UNITED STATES PATENT AND TRADEMARK OFFICE

APPLICATION NO.	FILING DATE	FIRST NAMED INVENTOR	ATTORNEY DOCKET NO.	CONFIRMATION NO.
09/819,969	03/28/2001	Masaki Ohya	14458	4222

Office Action Summary

DETAILED ACTION

FIG. 21A

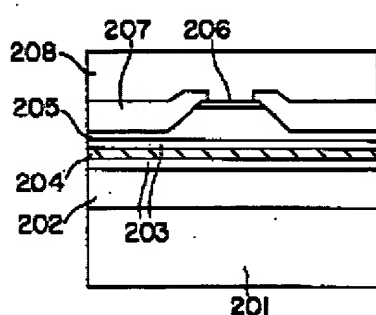
Claims 1-4 and 9-12 are rejected under 35 U.S.C. 102(b) as being anticipated by Kidoguchi et al (PN 5,502,739).

In figure 21A Kidoguchi et al illustrates AlGaInP cladding layers (202,205), a multiple quantum well (204) having 5 well layers (211) of GaInP shown in figure 21B and current block layer (207), see column 18 example 5.

Claims 5-8 rejected under 35 U.S.C. 103(a) as being unpatentable over Kidoguchi et al (PN 5,502,739).

In figure 21A Kidoguchi et al illustrates AlGaInP cladding layers (202,205), a multiple quantum well (204) having 5 well layers (211) of GaInP shown in figure 21B and current block layer (207), see column 18 example 5.

Kidoguchi et al does not disclose the misorientation, however it would have been an obvious matter of design choice to provide the misorientation in the laser system, since the misorientation does not solve any stated problem because applicant has
